THE LEGACY AT SAYBROOK SUBDIVISION, UNIT 1A

APPLICATION NUMBER 11 DATE May 18, 2017

REQUEST Subdivision

DETAIL SITE PLAN

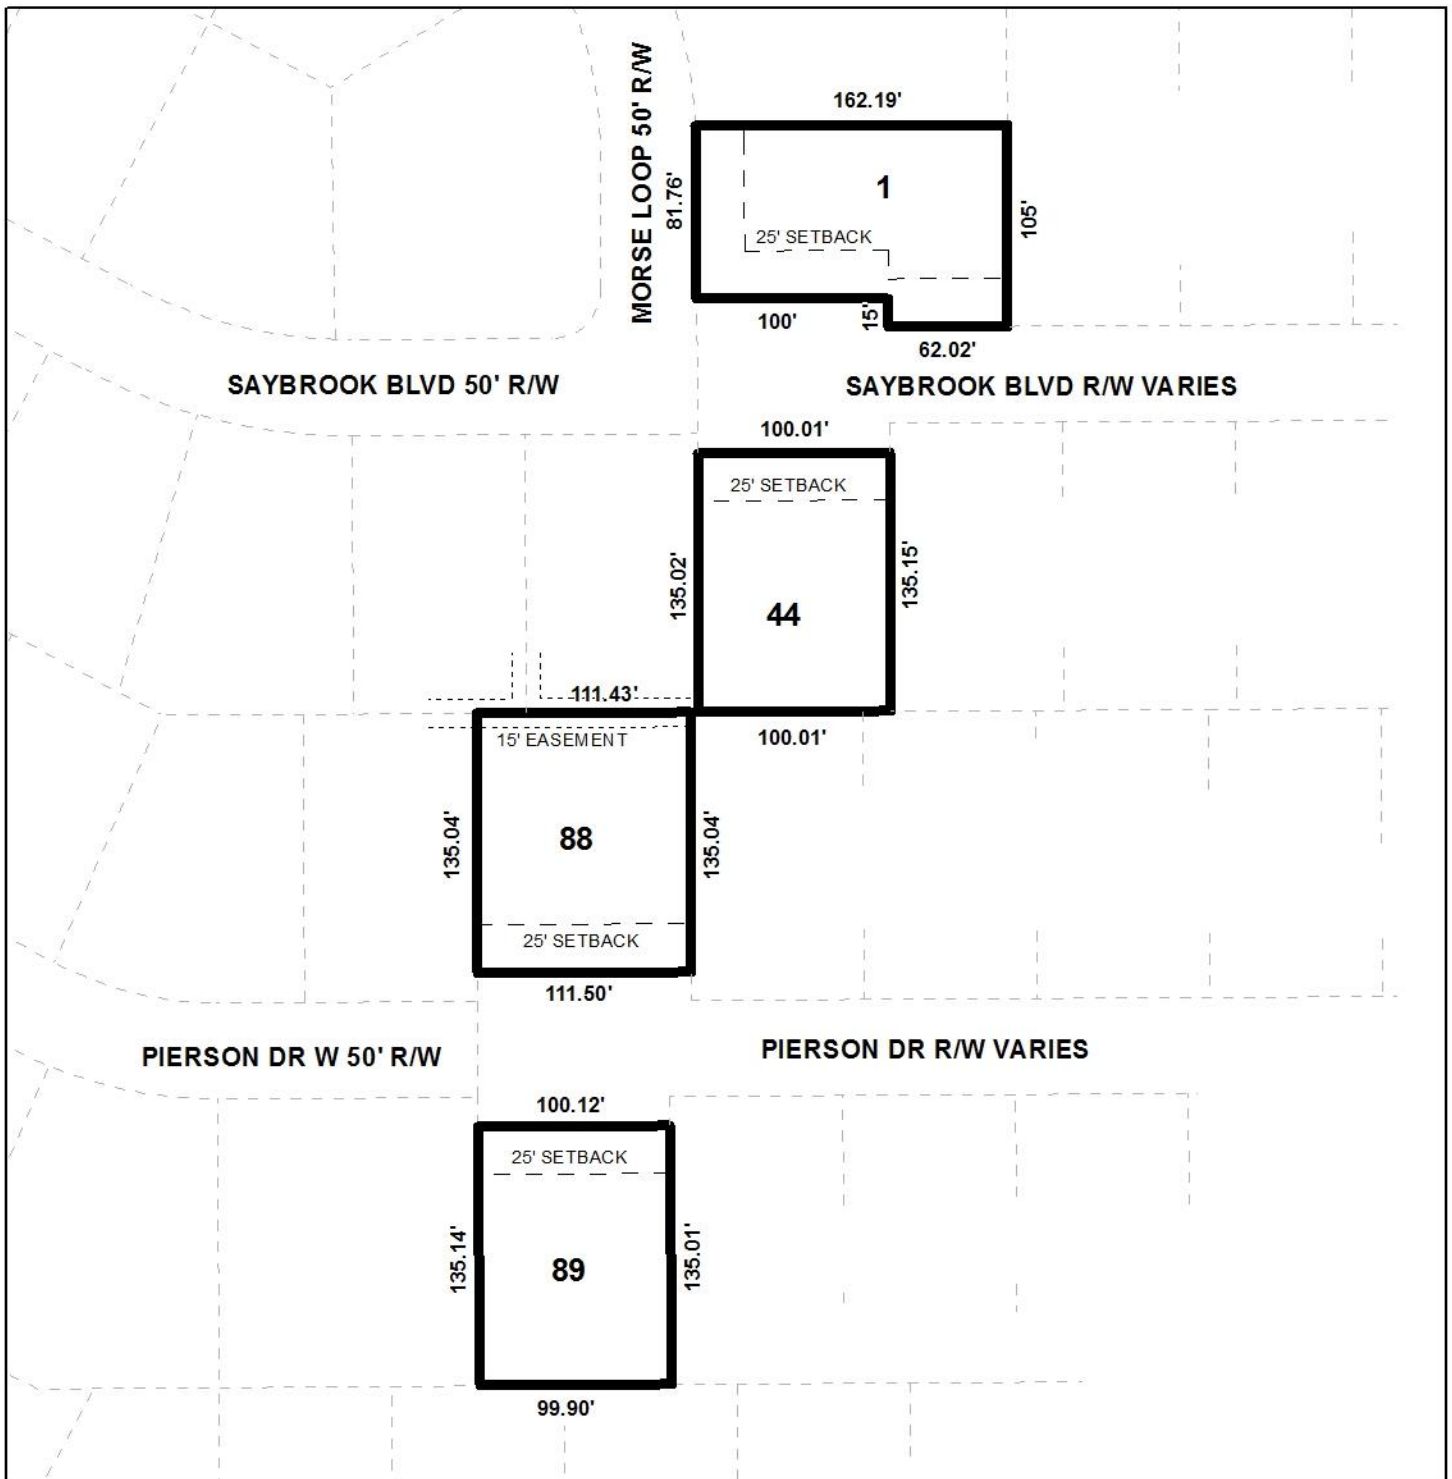
As the Subdivision would retain the 80' right-of-way widths in front of the proposed lots, no dedication would be required. Lot 1 would be a corner lot with portions having frontage on the compliant 50' right-of-way of Saybrook Boulevard and Morse Loop, also with a compliant 50' right-of-way. Therefore, no dedication would be required. The 25' minimum building setback line along all street frontages is indicated on the plat and should be retained on the Final Plat.

The plat indicates a 15' drainage easement along the rear of Lot 88 and this should be retained on the Final Plat. A margin note indicates a 10' utility easement on all lot lines adjacent to rights-of-way and a 5' utility easement along all side lot lines. As these easements are not illustrated on the plat, the Final Plat should be revised to illustrate all easements. A note should be required on the Final Plat stating that no structures may be constructed or placed in any easement.

The proposed lots meet the minimum size requirements of the Subdivision Regulations. As on the preliminary plat, the lot size labels in both square feet and acres should be retained on the Final Plat, or a table should be furnished on the Final Plat providing the same information. The lot size in square feet for Lot 88 should be corrected from 1,3510 square feet to 13,510 square feet on the Final Plat.

- 1) retention of the 25' minimum building setback line along all street frontages;
- 2) retention of the 15' drainage easement along the rear of Lot 88;

- 3) revision of the plat to illustrate the 10' utility easement on all lot lines adjacent to rights-of-way as per the margin note on the preliminary plat;

- 4) revision of the plat to illustrate the 5' utility easement along all side lot lines as per the margin note on the preliminary plat;
- 5) placement of a note on the Final Plat stating that no structures may be constructed or placed in any easement;

- 8) correction of the lot size in square feet for Lot 88 from 1,3510 square feet to 13,510 square feet on the Final Plat;
